SAN FRANCISCO PLANNING DEPARTMENT

Addendum to Environmental Impact Report

Addendum Date: May 9, 2013
Case No.: 2005.0555E
Project Title: California Pacific Medical Center (CPMC) Long Range Development Plan
EIR: CPMC LRDP Final Environmental Impact Report (Final EIR)
SCH No. 2006062157, Certified April 26, 2012
Zoning: Various
Height and Bulk: Various
Block/Lot: Various
Lot Size: Various
Project Sponsor: California Pacific Medical Center
Lead Agency: San Francisco Planning Department
Staff Contact: Devyani Jain – (415) 575-9051
Devyani.Jain@sfgov.org

Figure 1-24: East Elevation Comparison of Revised Project to Previous Project

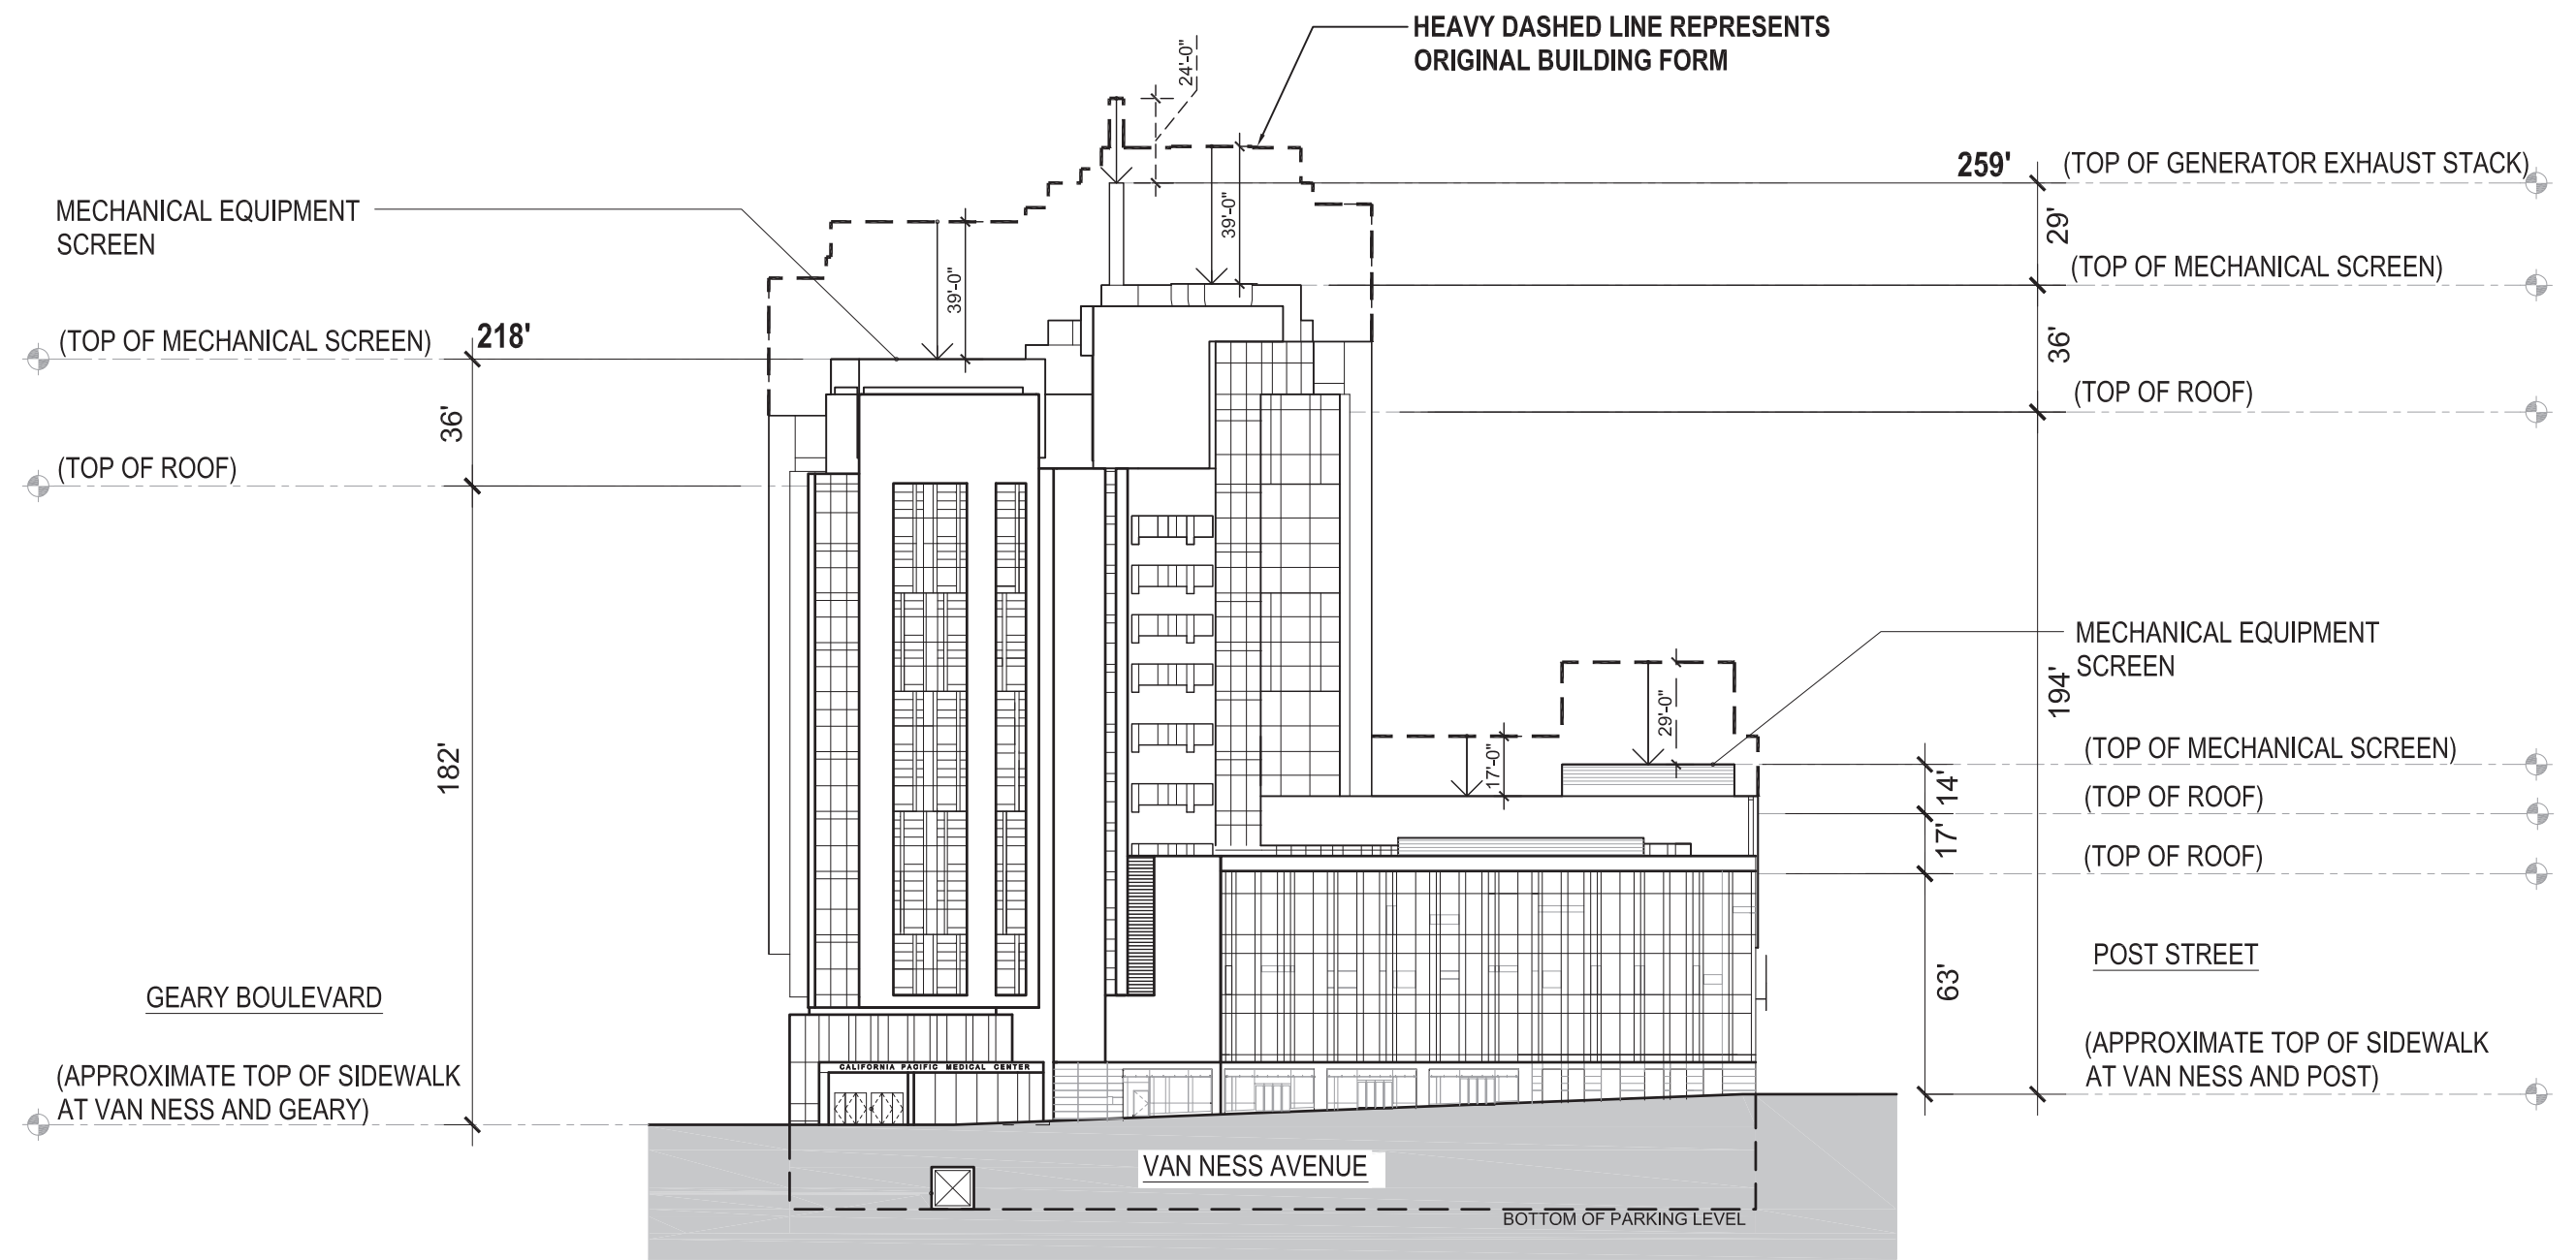
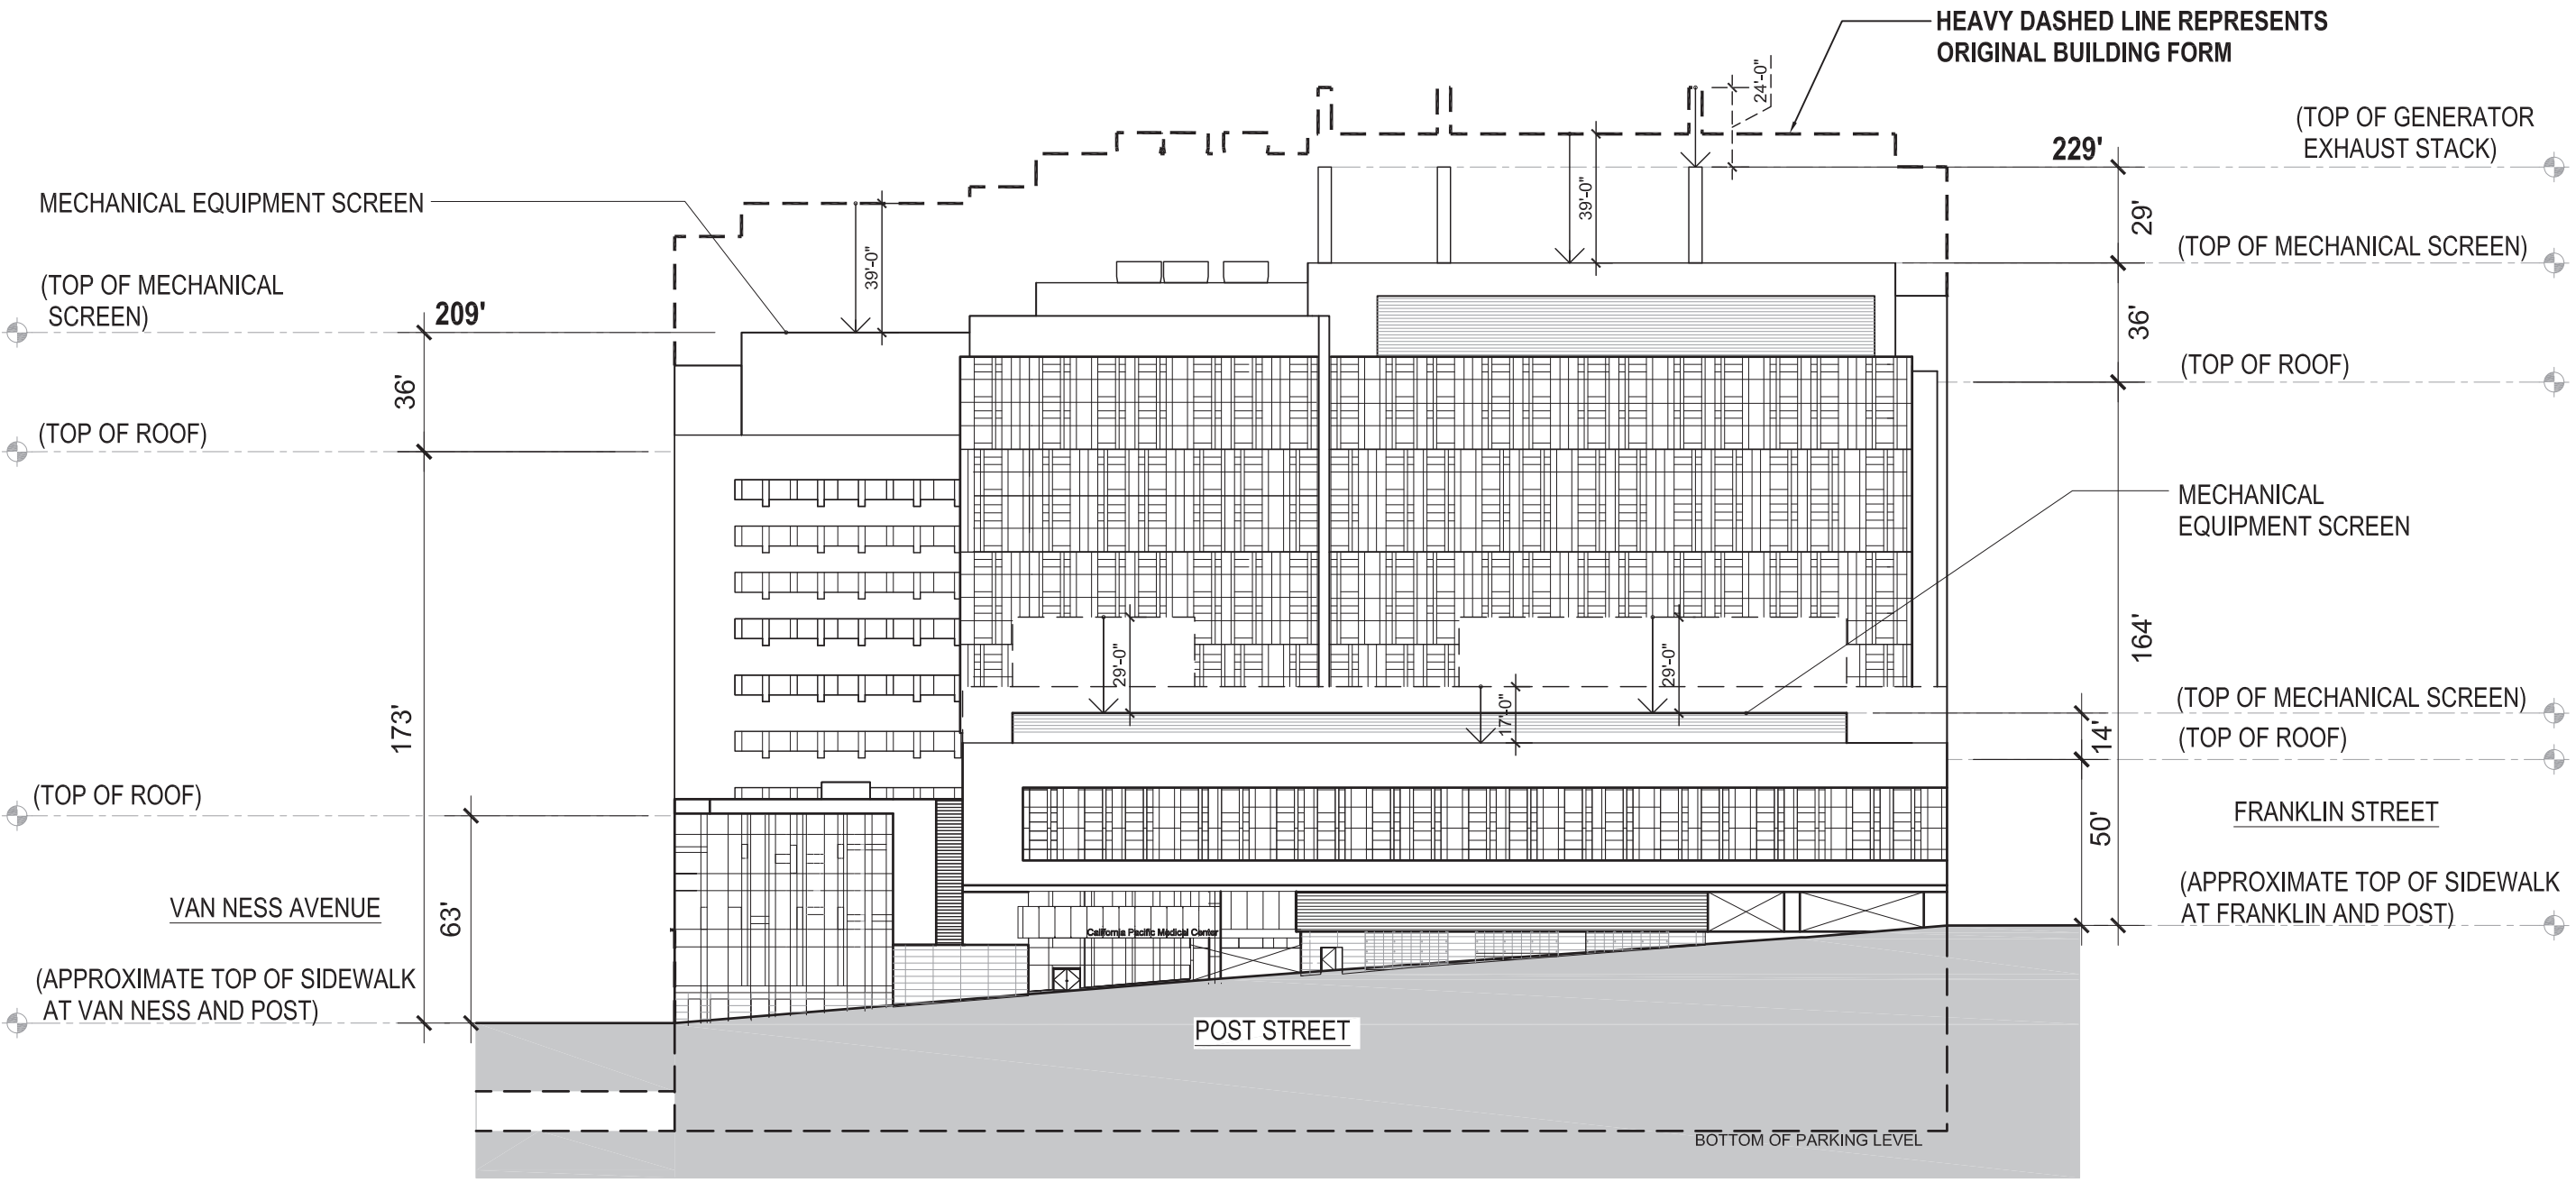
The Revised Project would reduce the originally proposed 265-foot-tall, 15-floor hospital tower by 39 feet or three floors, so that it would be a 226-foot-tall, 12-floor (plus two basement level) hospital tower under the Revised Project (see Figures 1-3 through 1-9). The building footprint and general design of the hospital under the Revised Project would remain the same as proposed for the Previous Project.

Project Component	Previous Project	Alternative 3A	Revised Project
Cathedral Hill Campus Hospital	The proposed Cathedral Hill Campus Hospital would be 1,163,798 gsf and contain 555 licensed acute care beds. The proposed hospital would reach 15 floors and 265 feet in height. The exterior design would consist primarily of metal and glass, with stone and concrete.	Under Alternative 3A, the proposed Cathedral Hill Campus Hospital would be 166,437 gsf smaller in size than under the Revised Project and 340,997 gsf less than the Previous Project and would include 96 more beds than the Revised Project. The hospital would also be 96 feet and three floors shorter than under the Revised Project.	While all other features would remain the same as the Previous Project, the Revised Project would eliminate approximately 174,560 gsf with a total reduction of three floors (two in the tower, one in the podium). The Revised Project hospital would be 39 feet shorter than the Previous Project and include 251 fewer licensed beds, for a total of 304 beds. The hospital footprint would remain the same, and no changes are proposed to the exterior design, except for the reduction of three floors.

Figure 1-39: North Elevation Comparison of Revised Project to Previous Project

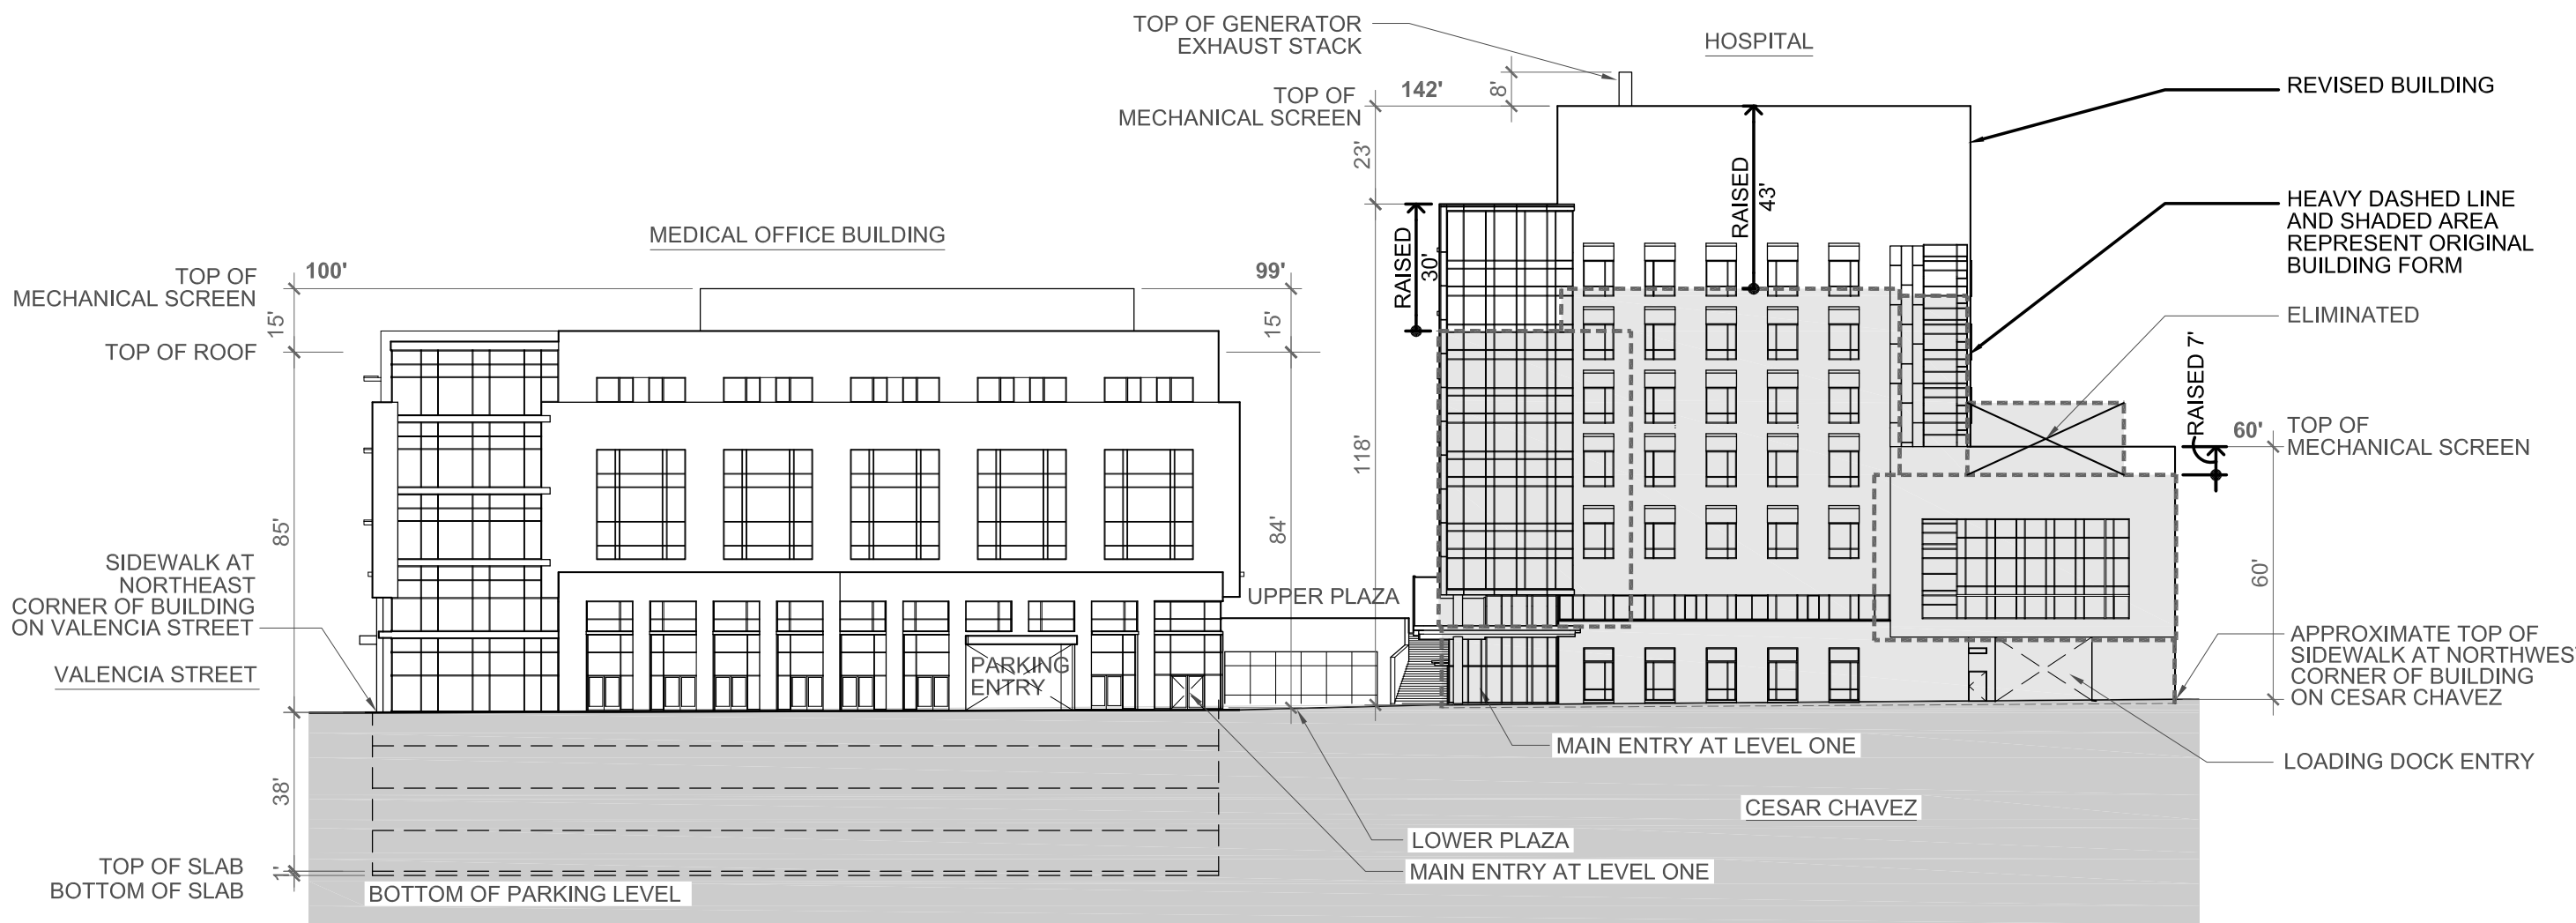
The principal changes at the St. Luke's Campus are shown in Table 2-2 and include the following: an addition of two floors (increasing the total from five to seven floors) and 43 feet (increasing the total height from 99 to 142 feet); 80,890 gsf of hospital space (increasing the total hospital floor area from the previously planned 154,800 to 235,690 gsf); and 40 additional licensed acute care beds (increasing the total from 80 to 120 beds) at the proposed St. Luke's Campus Hospital. The 80,890 gsf of additional hospital space includes an approximately 5,049-gsf building connector between the St. Luke's Campus Hospital and St. Luke's Campus MOB, which was attributed to the St. Luke's Campus MOB under the Previous Project. However, the building connector would be attributed to the St. Luke's Campus Hospital building under the Revised Project. This is because under the Revised Project, the building connector would be constructed concurrently with the hospital rather than with the St. Luke's Campus MOB, resulting in a net addition of 75,841 gsf at the St. Luke's Campus under the Revised Project as compared to the Previous Project. There would be no change to the parking spaces and building footprints at the St. Luke's Campus as compared to the Previous Project. However, there would be an incremental increase in the number of vehicular trips due to the additional 75,841 gsf (and 40 more beds) of hospital development associated with the Revised Project. Although the footprint of the St. Luke's Campus Hospital would not change, there would be approximately 9,000 additional cubic yards of excavation below grade (increasing the total excavation at the St. Luke's Campus from 61,400 under the Previous Project to 70,400 cubic yards under the Revised Project). There would be no change in the number of basement levels.

The two additional new hospital floors under the Revised Project would visually resemble the lower floors of the hospital under the Previous Project. The exterior design and architectural treatment of the two new floors would be similar to the design of the floors below and the same building façade materials would be used. Under the Revised Project, the St. Luke's Campus Hospital's exterior design would consist primarily of concrete, metal and glass, similar to the St. Luke's Campus Hospital design analyzed in the Final EIR for the Previous Project. Figures 1-30 through 1-32 includes elevations from each side of the campus. Figures 1-39 through 1-41 show a comparison of the North, South, East, and West Elevations of the hospital under the Previous Project to those of the Revised Project.
